Subject: RE: Re. Reactive Maintenance works at Donemark Bridge (CC-N71-009.00)

Having performed screening for Appropriate Assessment in respect of the proposed reactive maintenance works detailed in the email received from Paul O'Donoghue PhD dated the 4th of November, 2019, and entitled 'Re. Reactive Maintenance works at Donemark Bridge (CC-N71-009.00)', I accept the recommendations of Atkins Limited that the proposed reactive maintenance works, individually or in combination with other plans or projects, would not be likely to have a significant effect on any European site in view of the best scientific knowledge and the site's conservation objectives. I determine that an Appropriate Assessment of these proposed works is not required, as it can be excluded on the basis of objective scientific information following the screening done that the proposed works, individually or in combination with other plans or projects, will have a significant effect on any European site.

Re. Reactive Maintenance works at Donemark Bridge (CC-N71-009.00)

The structure location is here (bridge location circled in Red): -

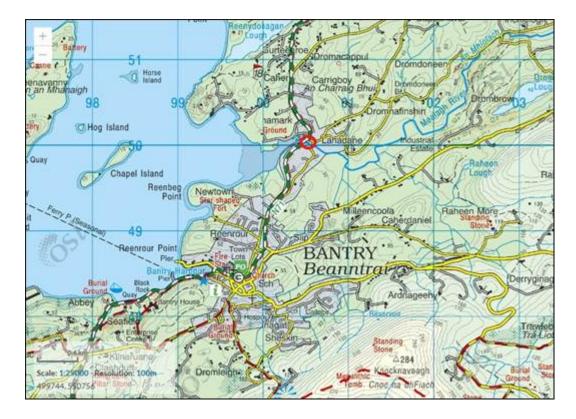
On a separate note, it should be stressed that ecological impacts, generally, must be avoided. The presence of knotweed (apparent in the photographs), giant rhubarb (apparent from Google maps) and Indian balsam (mentioned below) should be noted. Furthermore, freshwater pearl mussel must be dealt with appropriately.
